TO: Mercedes-Benz and Freightliner Dealer Principals, General Managers, Sales Managers, Service Managers, Parts Managers	FROM: Anthony Washington, Department Manager, Regulations and Certifications
RE: <b>Launch Recall Campaign Notification Model 907 (Sprinter) Model Years 2019 Flange Connection</b>	DATE: April 7, 2020

Campaign No. 2020030012, April 2020

SUBJECT: **Model 907 (Sprinter), Model Year 2019  
Flange Connection**

D09.40-A014-09

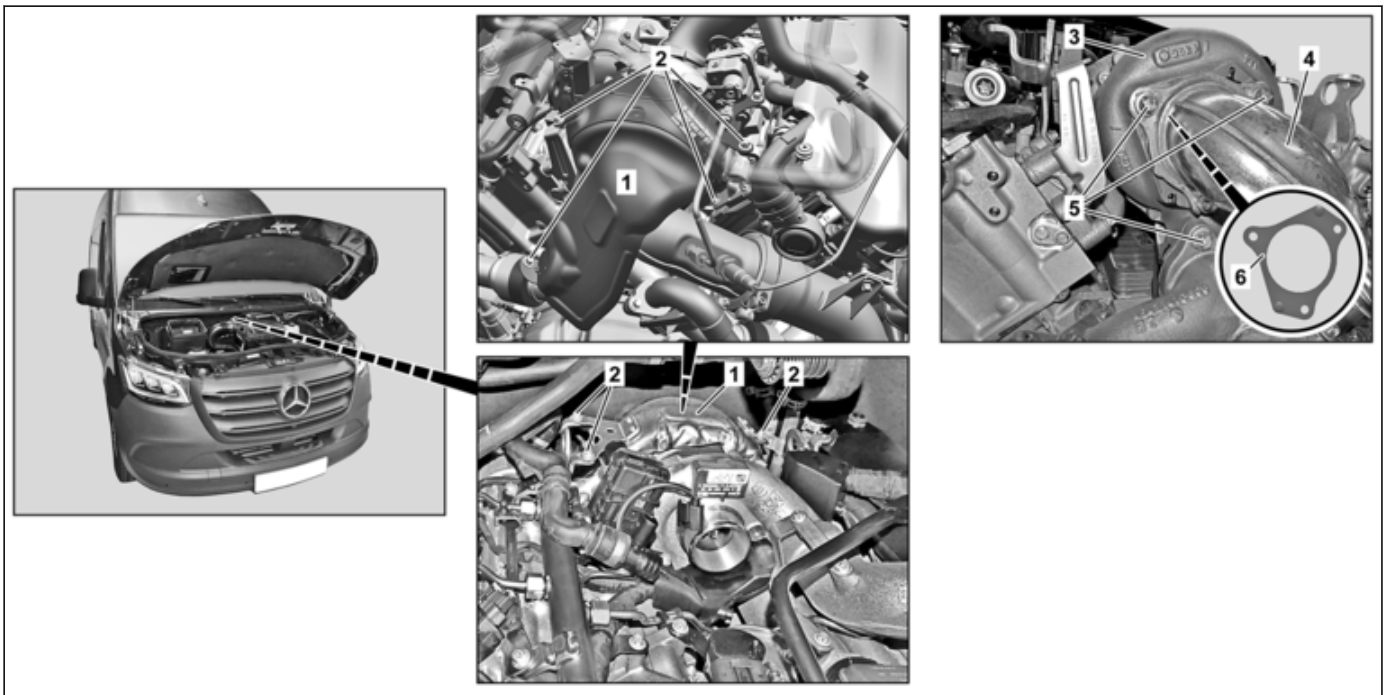
Mercedes-Benz AG (“MBAG”), the manufacturer of Mercedes-Benz and Freightliner vans, has determined that on certain Sprinter vehicles from platform 907 (VS30), the flange connection between the exhaust gas turbocharger and the exit to the diesel particulate filter may not have been attached properly. If the flange connection is not attached properly, high-temperature exhaust gas could potentially leak into the engine compartment, increasing the risk of a potential thermal reaction as well as thermal damage to the immediately surrounding components. An authorized Mercedes-Benz or Freightliner Sprinter dealer will replace the flange seals and will apply the correct torque to the screw connection.

<b>Remove</b>		
2	Remove air filter housing.		AR09.10-D-1150TSV
 AR			
3	Remove engine cover.		AR01.10-D-2405TSV
 AR			
4	Remove heat shield (1).	 To do this, remove screws (2).	
5	Remove bolts (5).	 Screws (5) are replaced.	
6	Remove seal (6) between exhaust gas turbocharger (3) and exhaust pipe (4).	 Seal (6) is replaced.	
	<b>Install</b>		
7	Position new seal (6) between exhaust gas turbocharger (3) and exhaust pipe (4) then fit new screws (5).	 Check seal (6) is in correct installation position. Otherwise, leaks can occur in the exhaust system.	
8	Tighten bolts (5).	 Bolt, exhaust pipe to turbocharger	<a href="#">BA09.40-N-1008-02TSV</a>

9	Install heat shield (1).	 To do so, screw in and tighten screws (2).  Bolt, heat shield to bracket  Bolt, heat shield to exhaust collector pipe	<a href="#">BA09.40-N-1009-02TSV</a> <a href="#">BA09.40-N-1010-02TSV</a>
10	Install engine cover.		AR01.10-D-2405TSV
11	Install air filter housing.		AR09.10-D-1150TSV
	<b>Check</b>		
	 <b>Warning</b>		
12	<p><b>Risk of accident</b> from vehicle starting off by itself when engine running. <b>Risk of injury</b> (bruises and burns) resulting from working on the engine while it is being started or when it is running.</p> <p>Check for leak tightness when engine is running.</p>	<p>Secure vehicle to prevent it from starting off by itself. Wear closed and snug-fitting work clothes. Do not touch hot or rotating parts.</p> <p> Visual inspection only.</p>	AS00.00-Z-0005-01A

Number	Designation		Engine 642 in model 907
BA09.40-N-1008-02TSV	Bolt, exhaust pipe to turbocharger	Nm	20

Number	Designation		Engine 642 in model 907
BA09.40-N-1009-02TSV	Bolt, heat shield to bracket	Nm	8

Number	Designation		Engine 642 in model 907
BA09.40-N-1010-02TSV	Bolt, heat shield to exhaust collector pipe	Nm	12
